Re: Mariposa Energy Project
CEC Docket #09-AFC-03

As vice-chair of the Contra Costa County Airport Land Use Commission, I write this letter independent from the commission to follow up on a few points in our commission's letter of November 30, 2009.

24-HOUR DATA
(18,809 Observations)

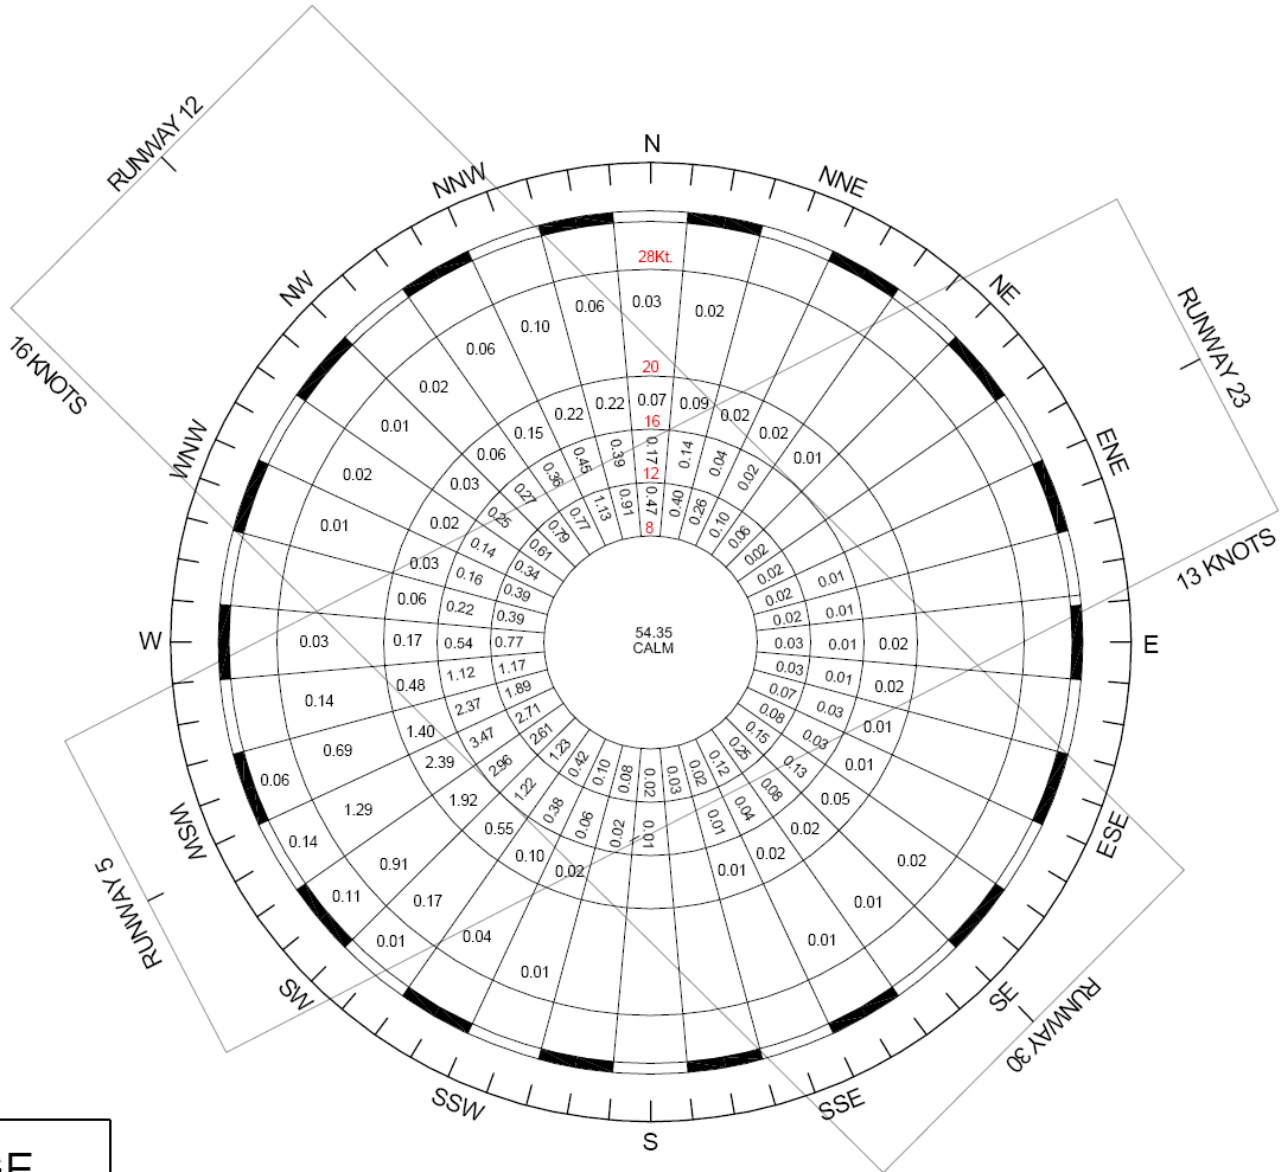
1. Attached to this e-mail is an enlarged copy of the wind rose for the Byron Airport for use with our Information Request #4 in our letter of November 30.
